**THE REGIONAL MUNICIPALITY OF YORK  
ADDENDUM # 5  
T-16-11**

**FOR: Construction of the New Paramedic Response Station# 19**  
**LOCATION: 415 Harry Walker Parkway South, in the Town of Newmarket, Ontario**  
**CLOSING: November 15, 2016 at 1:00 P.M. (Local time)**

## Civil Tender Addendum # 1

**Project:** Proposed York Region EMS Station  
**Project No:** 2015-075  
**Location:** 415 Harry Walker Parkway South, Newmarket ON  
**Date:** November 2<sup>nd</sup>, 2016  
**Architect:** Thomas Brown Architects.  
**Contact:** Sebastian Lubczynski  
**Subject:** Alterations to MH 1, CB2, DCB 1 and sanitary sewer pipe slope between MH A4 and existing sanitary manhole

**ADD 1.2**

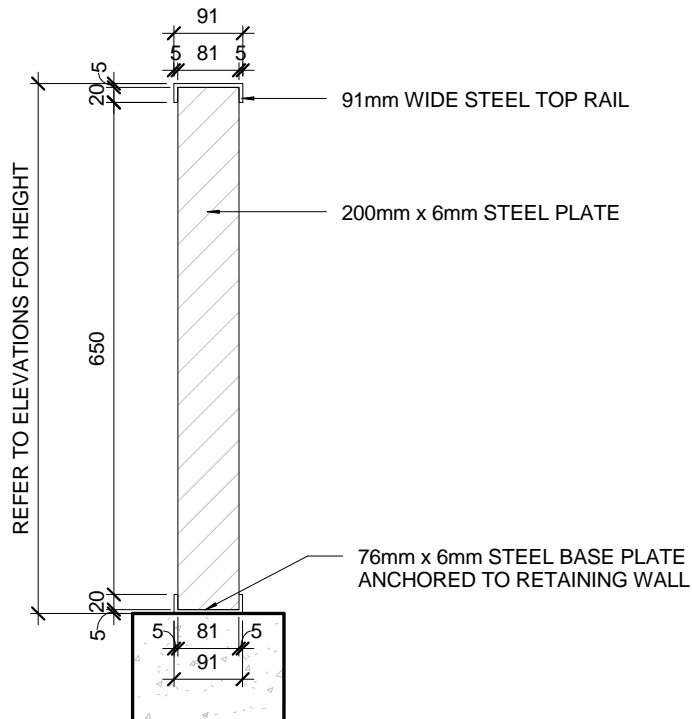
1. Refer to Drawing A1.5 – Railing elevations and details

1. Revise Detail 9 - Railing section detail with the attached Drawing AD 1.2 Railing Section Detail

The following describes the required changes to the contract drawing, (CV-2)

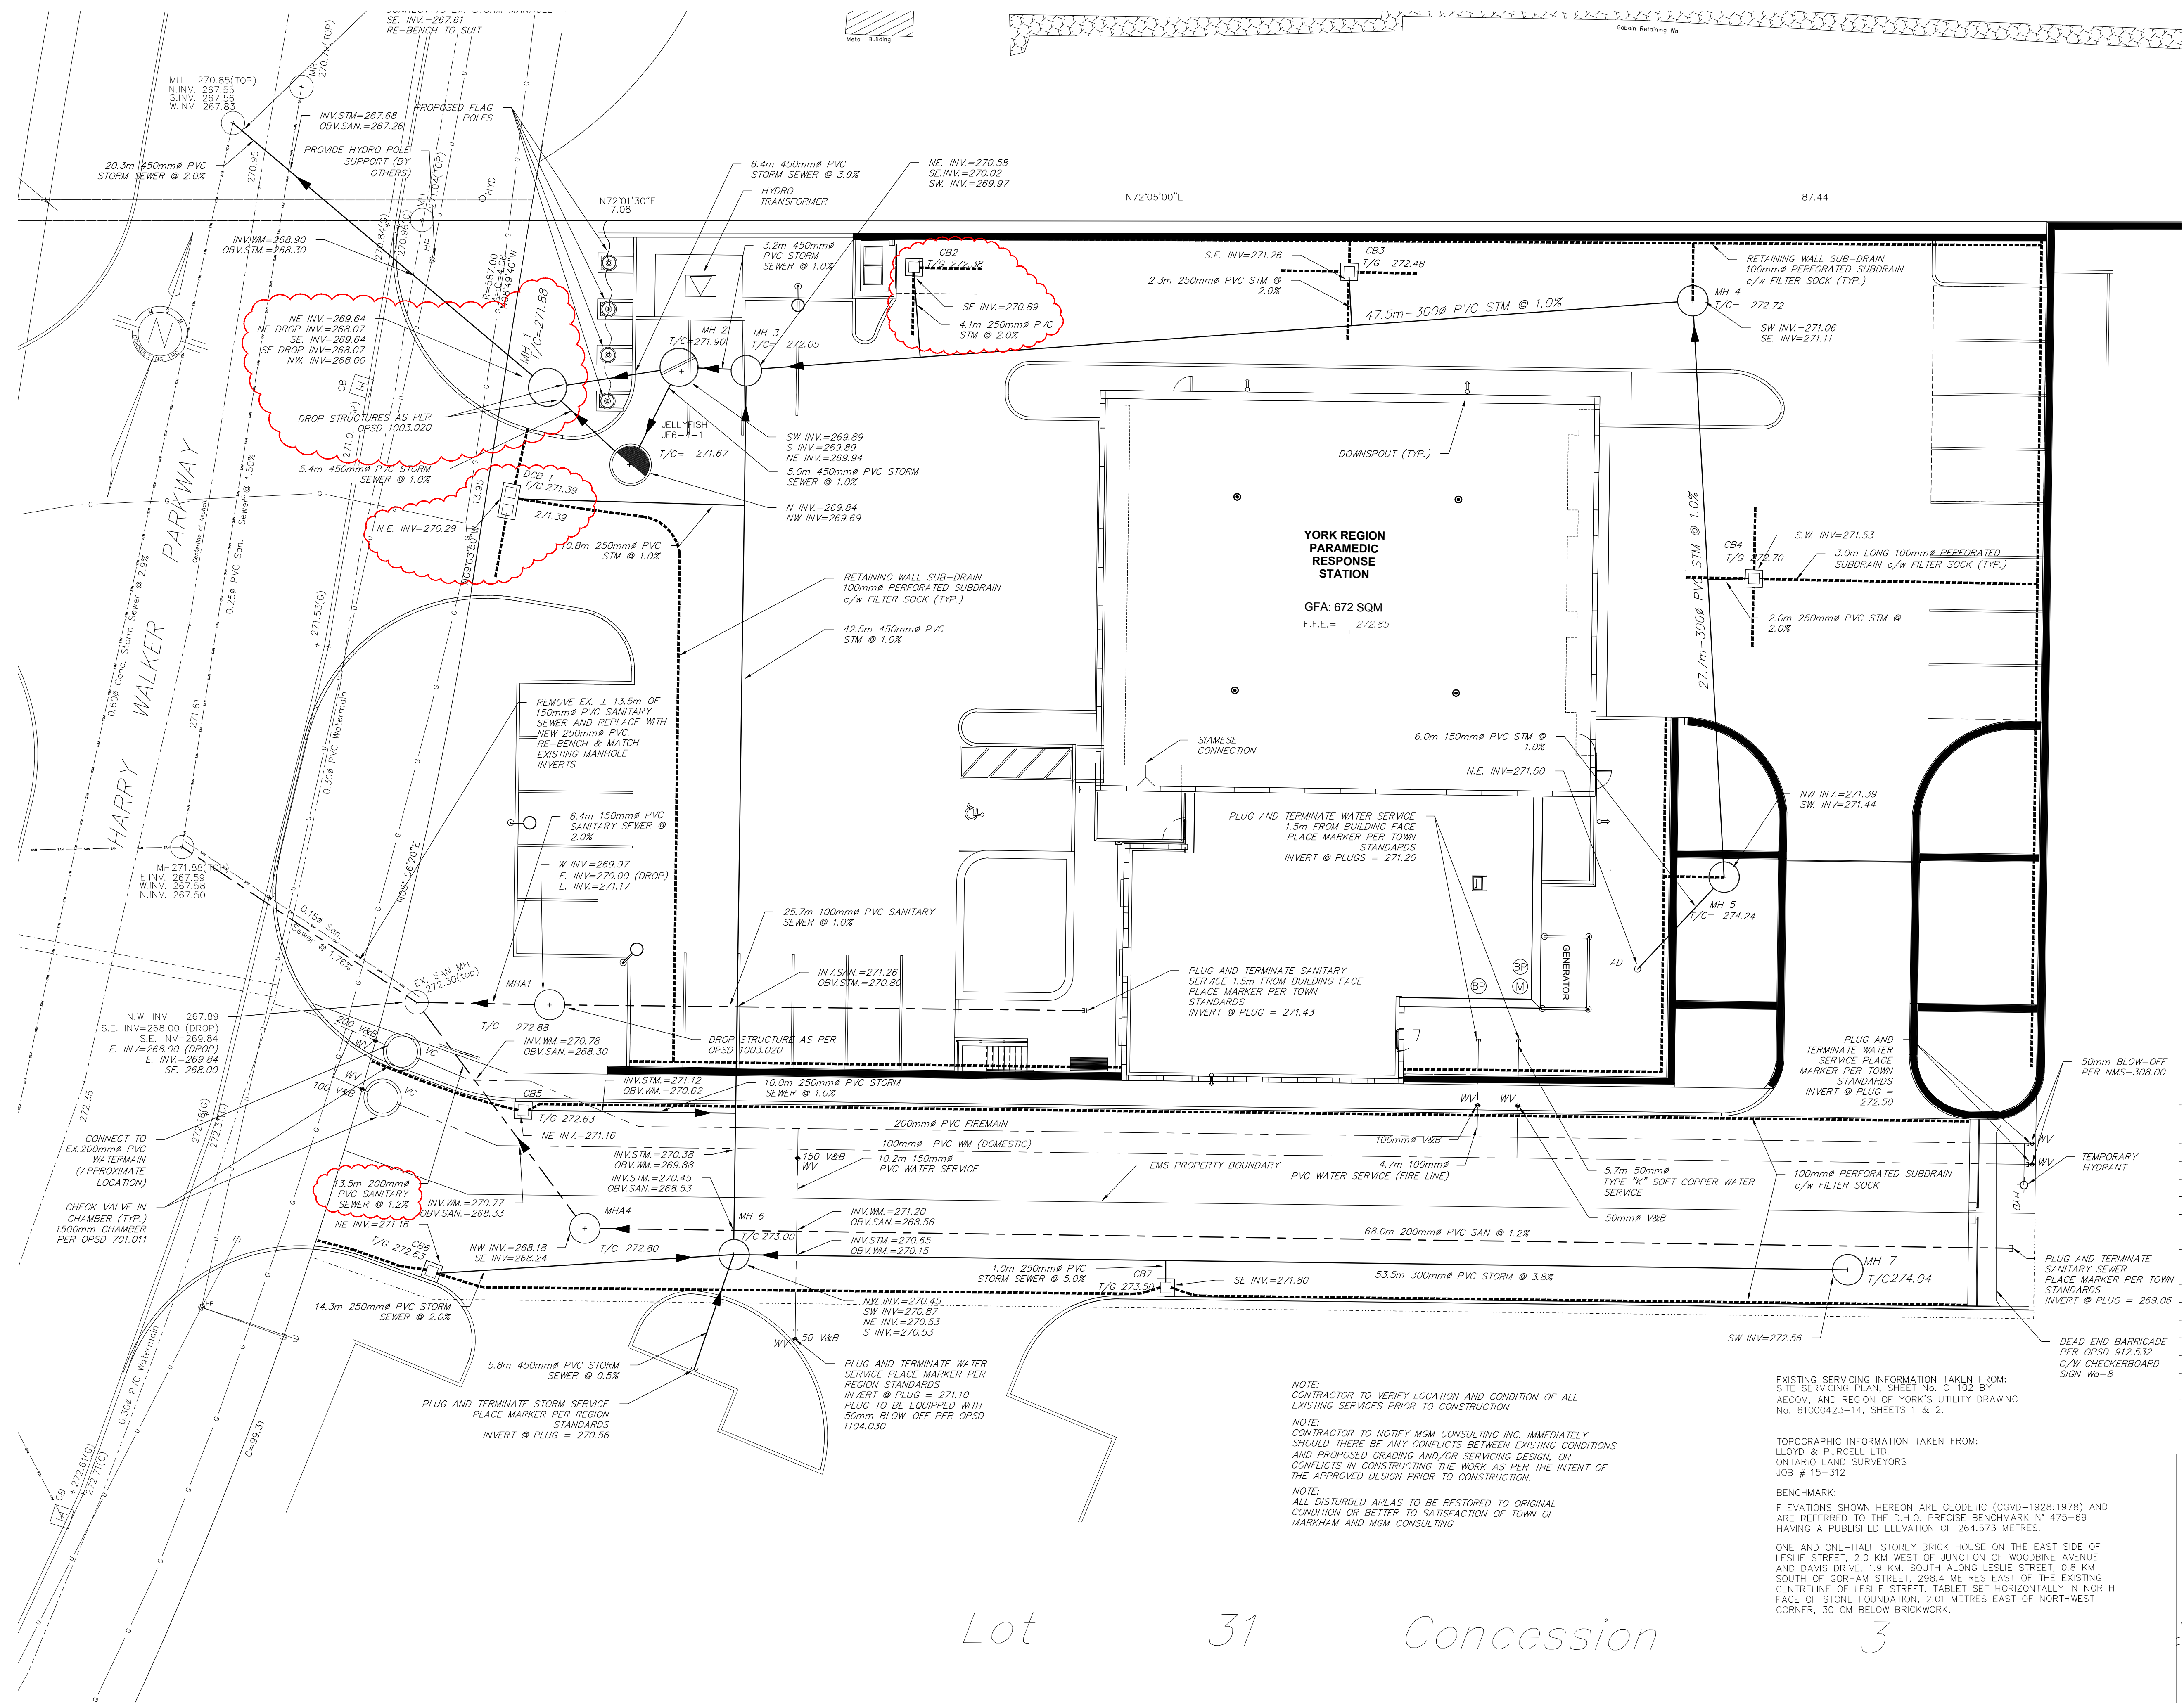
- Two drop structures are required on the inlets to MH1. The drop structure shown on the outlet of MH1 to be deleted.
- Southeast invert on CB2 must be revised from 262.37 to 270.89
- Northeast invert on DCB 1 must be revised from 269.93 to 270.29
- Sanitary sewer slope from MH A4 to existing sanitary manhole must be revised from 2.0% to 1.2%.
